KANSAS GAS AND ELECTRIC COMPANY

KMLNRC 86-176  
Re: Docket No. STN 50-482  
Subj: Large Break LOCA Analysis

LARGE BREAK LOCA ANALYSIS  
USING THE BART COMPUTER CODE

**SNUPPS** *Wolf Creek*  
**FIGURE 15.6-5**  
**CODE INTERFACE DESCRIPTION FOR**  
**LARGE BREAK MODEL**

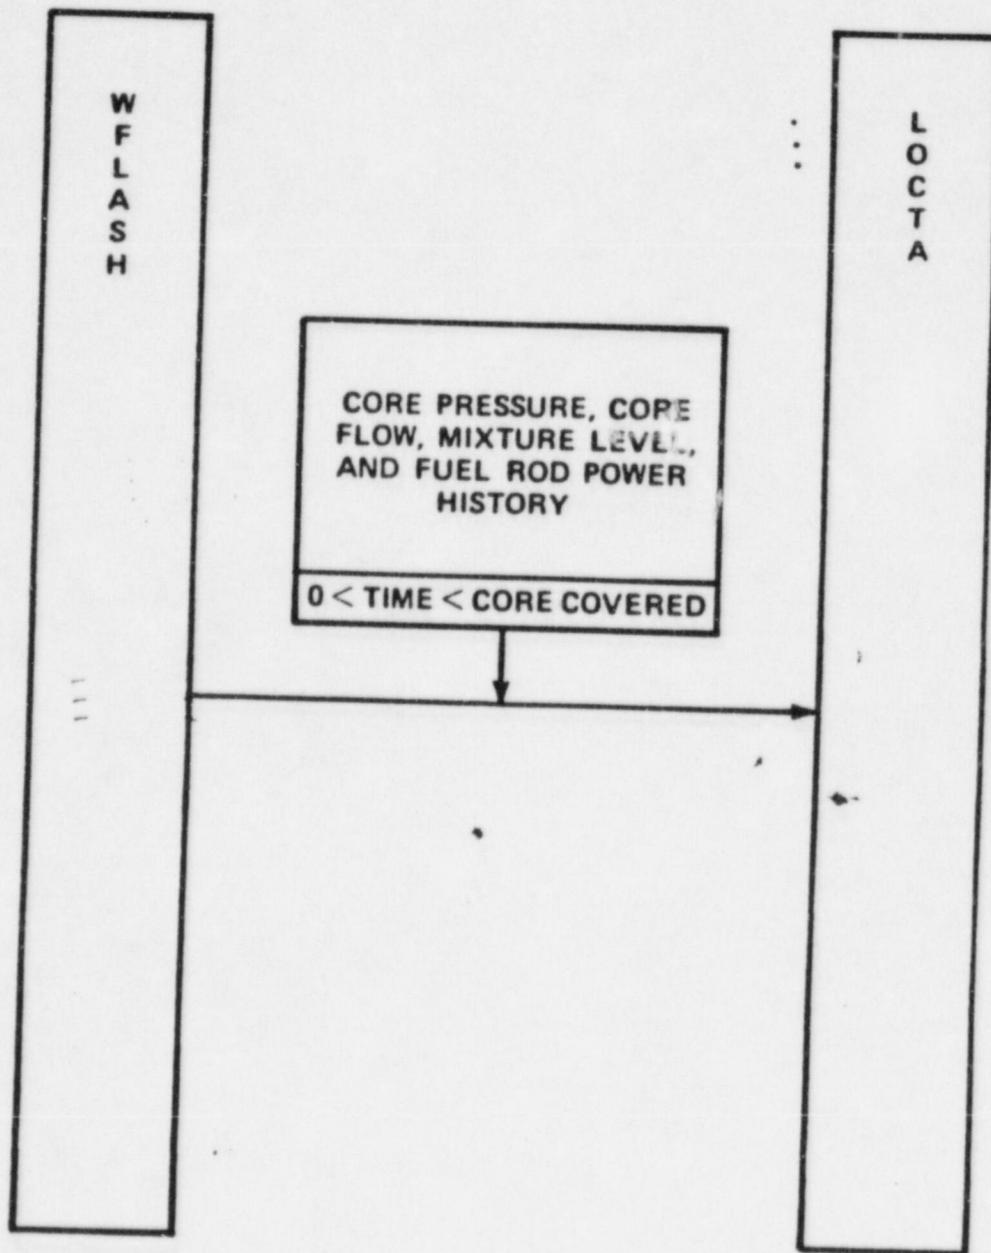
With input from the SATAN-VI code, WREFLOOD uses a system thermal-hydraulic model to determine the core flooding rate (i.e., the rate at which coolant enters the bottom of the core), the coolant pressure and temperature, and the quench front height during the refill and reflood phases of the LOCA. WREFLOOD also calculates the mass and energy flow addition to the containment through the break. Since the mass flow rate to the containment depends upon the core flooding rate and the local core pressure, which is a function of the containment backpressure, the WREFLOOD and COCO codes are interactively linked. ~~WREFLOOD is also linked to the LOCTA-IV code in that~~ Replace with thermal-hydraulic parameters from WREFLOOD are used by LOCTA-IV insert D in its calculation of the fuel temperature. LOCTA-IV is used throughout the analysis of the LOCA transient to calculate the fuel clad temperature and metal-water reaction of the hottest rod in the core. ← insert E

A schematic representation of the computer code interfaces for large break calculations is shown in Figure 15.6-5.
